**As-built Baseline Monitoring Report**  
**FINAL**  
**Greenbrier Stream Mitigation Project**  
**Yadkin County, North Carolina**  
**Monitoring Year 0**

NCDEQ Contract No. 7616  
DMS ID No. 100086  
USACE Action ID No. SAW-2018-01755  
NCDWR ID: 20181272

**RE: Response to Draft As-Built Baseline Monitoring Report (MY0) Comments dated July 24, 2020  
Greenbrier Stream Mitigation Site  
Yadkin River Basin – CU# 03040101 - Yadkin County, North Carolina  
NCDMS Project # 100086, Contract # 7616**

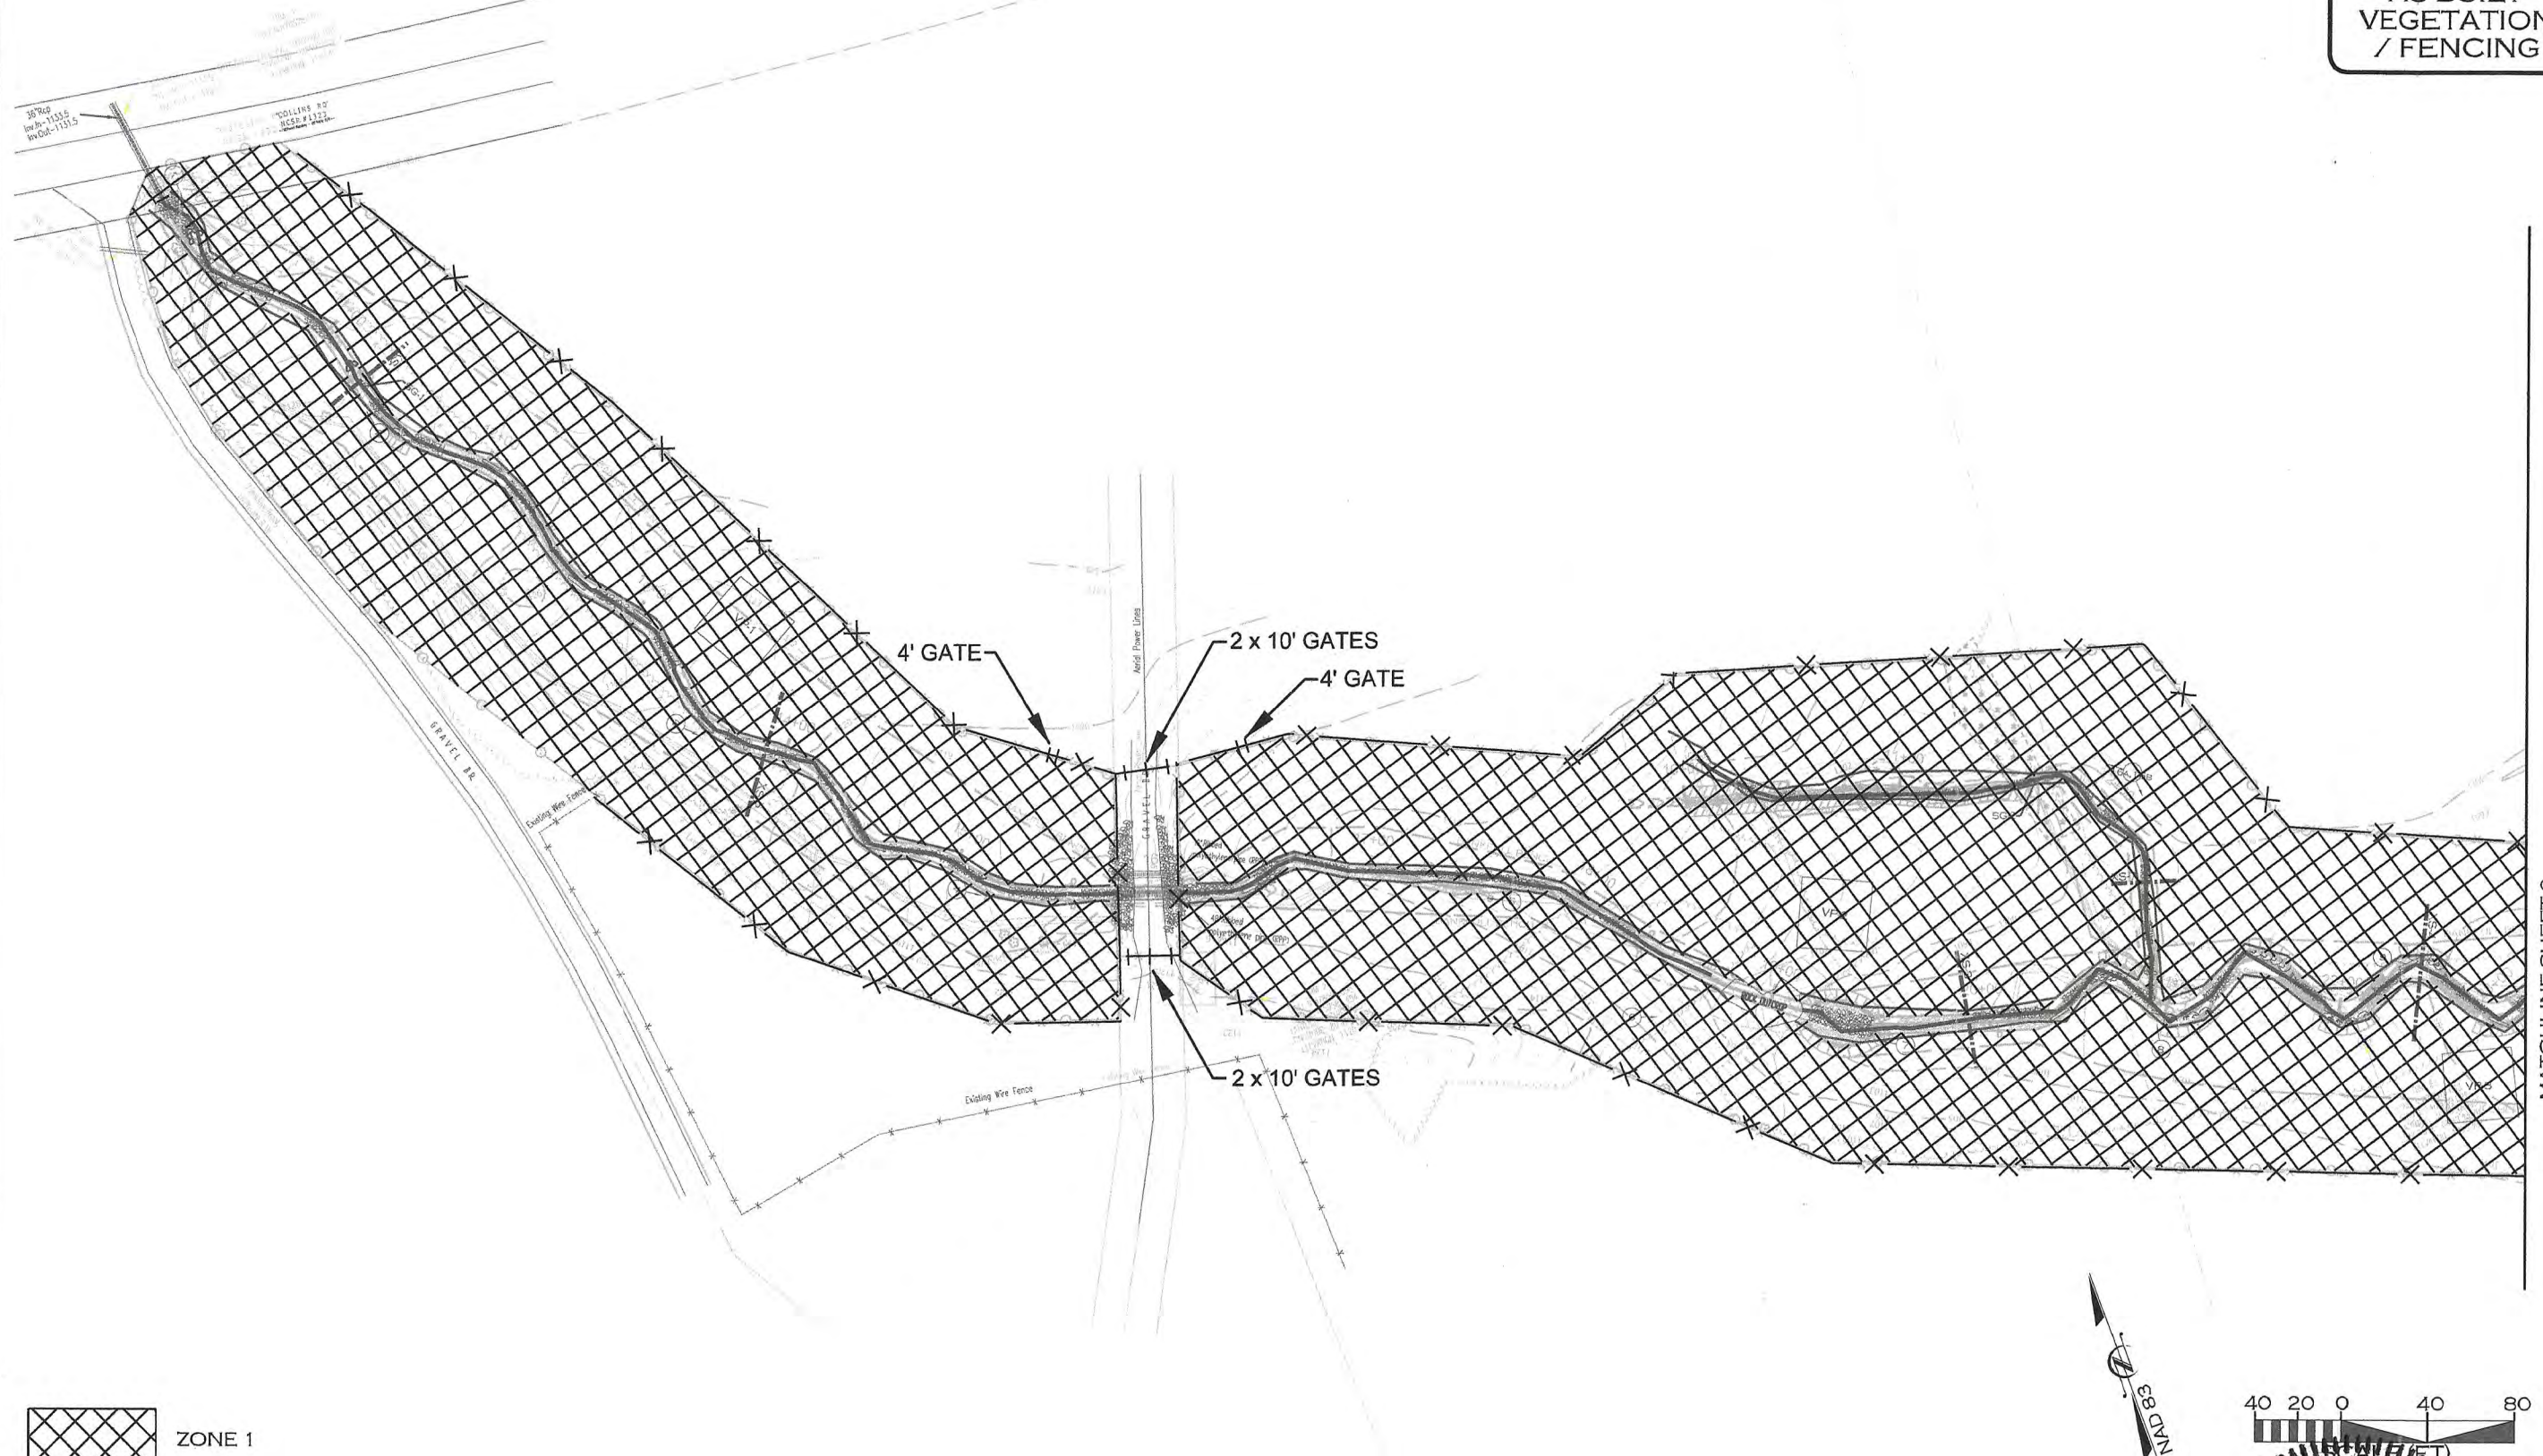
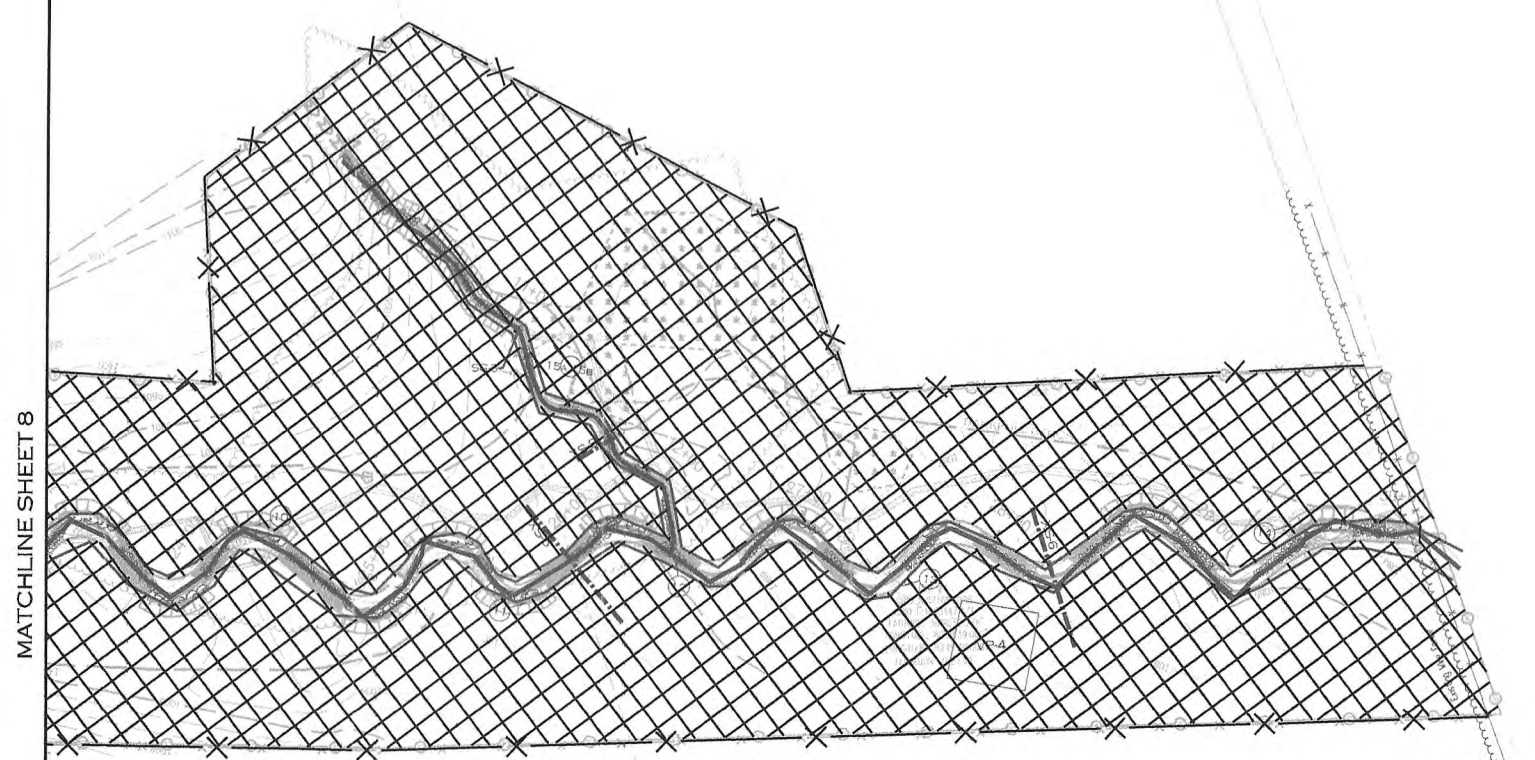
- *Appendix E: Record Drawings: Please also provide Record Drawing planting sheets noting any planting substitutions/ deviations from the IRT approved mitigation plan's planting plan (Appendix 8 Sheets 3B, 9, and 10 in the IRT approved mitigation plan). Planting deviations and substitutions should be shown in red.*

- **There were no planting substitutions or deviations from the IRT approved mitigation plan's planting plan. Two plan sheets have been added to the As-Built plans to show the planting plan.**

ALL PLANTING WAS COMPLETED ACCORDING TO THE THE DESIGN AND THERE WERE NO DEVIATIONS FROM THE PLANTING PLAN.
